## MixMate

### MixMate as of S/N 15001

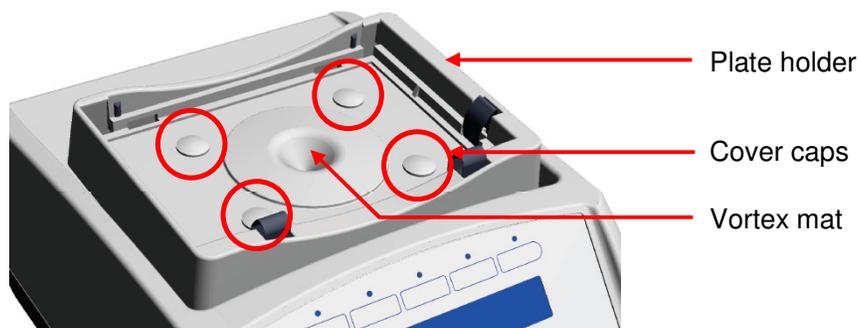
Vortex mats starting with S/N 10001 are glued to the plate holder to prevent liquid from entering the device. That meant that the vortex mat could no longer be removed and the screws below it, which are used to disassemble the device, could not be removed. Repair or service of the MixMate was temporarily unavailable.

A modified plate holder will be used starting with S/N 15001. The glued vortex mat now has cover caps, which can be removed as necessary, on the screw positions (see figure), which allow the MixMate to be disassembled or repaired. Devices which were manufactured before this change (S/N 10001 to 15000) can now be repaired again. The vortex mat must be cut open on the screw positions to disassemble the plate holder. Therefore, the old plate holder cannot continue being used; it must be replaced by the new plate holder with glued vortex mat and cover caps.
